VKPC 86619

Technical Bulletin - November 2009

Audi 100, A6
VW Crafter, LT, Transporter

OE/SKF DESIGN EVOLUTION

Pic 1: VKPC 86619

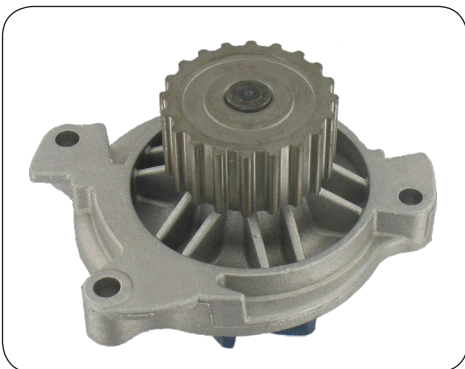
The above VAG applications were originally equipped with an 18-tooth water pump pulley.

VAG has modified the OES water pump with a 20-tooth pulley. To follow VAG's specifications, SKF has also modified the design of its VKPC 86619 (See *Pic 1*).
